CITY OF ALBUQUERQUE

Re: Carrillo Shop
1001 Old Coors SW
Traffic Circulation Layout
Engineer's Stamp 06-13-22 (L11-D010)

Based upon the information provided in your submittal received 09-16-22, the above referenced plan cannot be approved for Building Permit until the following comments are addressed:

TRANSPORTATION PLAN

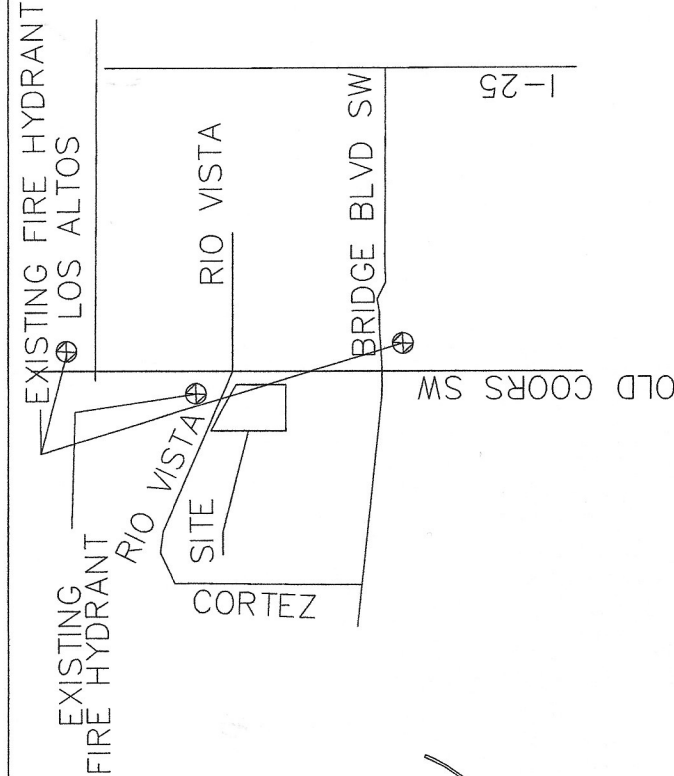
1. Identify all existing access easements and rights of way width dimensions, and provide the width for the existing sidewalk.
2. Identify the right of way width, medians, curb cuts, and street widths on Old Coors Dr.
3. Curb Return design need to be provided for both access driveways off Old Coors and Rio Vista Dr.
4. Clarify existing property lines and proposed property lines.
5. Access width for arterial, collector, and local streets are as follows:

6. Old Coors classified as Minor Arterial, and Rio Vista classified as Local street.
7. ADA curb ramp at the corner of Old Coors Dr. and Rio Vista Dr. must be updated to current standards and have truncated domes installed.
8. Please provide Motorcycle sign details.
9. Show all drive aisle widths and radii. Some dimensions are not shown.
10. The minimum drive aisle dimensions are shown below

11. List radii for all curves shown; for passenger vehicles. Radius for delivery trucks, fire trucks, etc. is 25 ft. or larger.
12. Per the IDO, a 6 ft. wide ADA accessible pedestrian pathway is required from the public sidewalk to the building entrances. Please clearly show this pathway and provide details.

13. Per DPM, a 6 ft. wide ADA accessible pedestrian pathway is required from the ADA parking stall access aisles to the building entrances. Please clearly show this pathway and provide details.

14. ADA accessible pedestrian pathway should not be placed behind parking space or adjacent to a vehicular way. Vehicle and pedestrian/wheel chair conflicts should be avoided as much as possible.

15. Curbing should be installed to delineate landscape, parking, and pedestrian ways and identify points of access. Please call out detail and location of barrier curb.

16. Parking areas shall have barriers to prevent vehicles from extending over public sidewalk, public right-of-way, or abutting lots.
17. Refuse vehicle maneuvering shall be contained on-site. The refuse vehicle shall not back into the public right of way.; provide a copy of refuse approval.

18. Provide a copy of Fire Marshall approval.
19. It is not apparent what type of pavement surface is being proposed. A hard driving surface will be required as part of this proposed project for parking area and drive aisles.

20. Please provide a sight distance exhibit
21. Show the clear sight triangle (on the site plan) and add the following note to the plan: "Landscaping and signage will not interfere with clear sight requirements. Therefore, signs, walls, trees, and shrubbery between 3 and 8 feet tall (as measured from the gutter pan) will not be acceptable in the clear sight triangle.

22. Please specify the City Standard Drawing Number when applicable.
23. Add a note stating "All broken or cracked sidewalk must be replaced with sidewalk and curb & gutter." A build note must be provided referring to the appropriate City Standard drawing.
